Docket: NRC-2017-0081

Greater-than-Class-C and Transuranic Waste; Draft Regulatory Basis

Document: NRC-2017-0081-DRAFT-0028

Chernobyl on the Texas Plains

Figure B-1 Doses to an Inadvertent Intruder from the Excavation Exposure Scenario

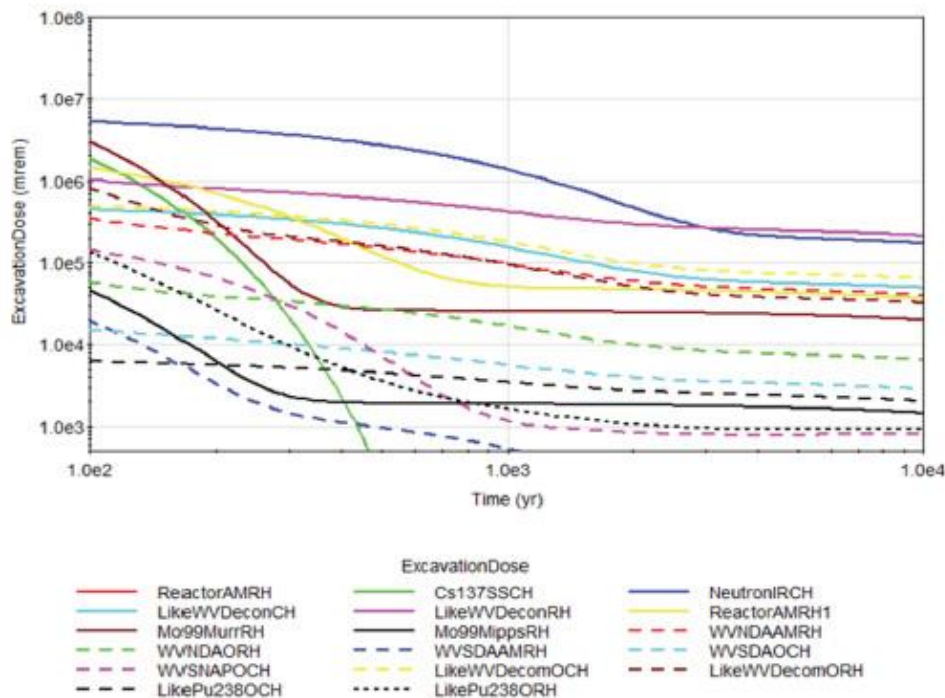
Example one - the homesteader contacts the waste by digging a cellar for his house. (Actually, Texans rarely dig cellars.)

Problem solved, they said.

Make a cement cover that will last 500 years and cover it with 5 meters of dirt. He'll never dig a cellar that deep.

Note that the midpoint of the graph is 1,000 years and the right side is 10,000 years. The site is still highly radioactive 10,000 years or 500 generations later. Using a 500-year timeline is irresponsible given the data.

Figure B-2 Doses to an Inadvertent Intruder from the Well Drilling Exposure Scenario

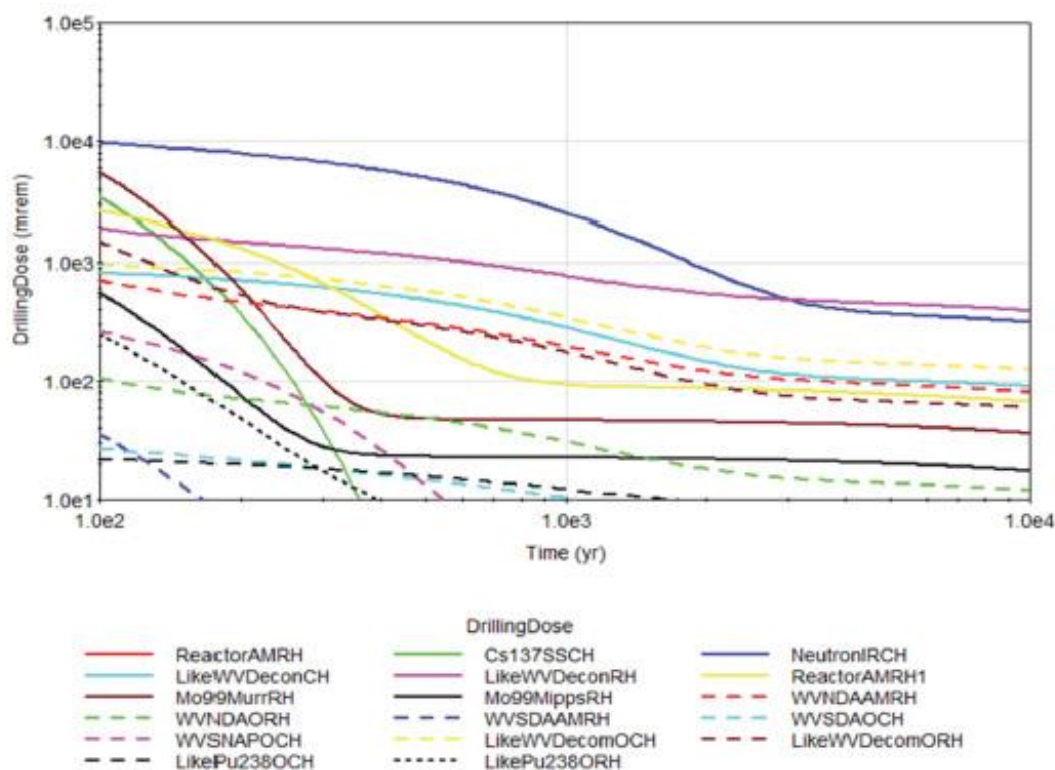
Secondly – suppose he drills a well for water – or oil – as is common in this area. He might puncture one of the containers and be exposed to its radioactive contents. Their solutions included:

- increase the allowable radiation exposure by a factor of twenty, from 25 to 500 millirems,
- suppose that the amount of time he was actually drilling was the extent of his exposure – not the time living by the well and drinking from it, and

- c.) suppose that the containers would be only one layer deep so he would only contact one container – in direct contradiction of piling many layers – maybe 100 feet deep in the current practice.

Laughable as these models are – they completely ignore the fact that the half-life of the three highest quantity transuranic nuclear isotopes of concern – in their own data - are as follows:

Figure B-5 Mean Dose Result for Each GTCC Waste Stream

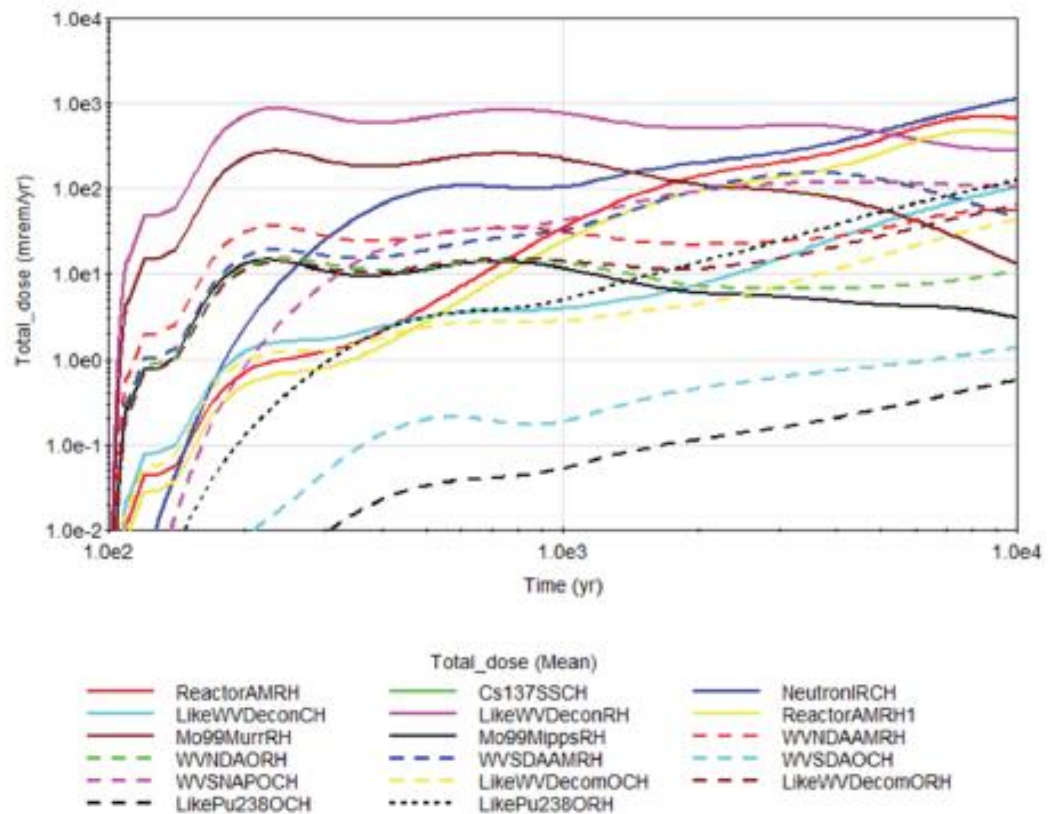
NRC's own charts show the problem off-site getting worse over time as the shallow disposal site begins to break down and natural processes spread its toxic radiation over wider and wider areas - well beyond the 10,000 years plotted here.
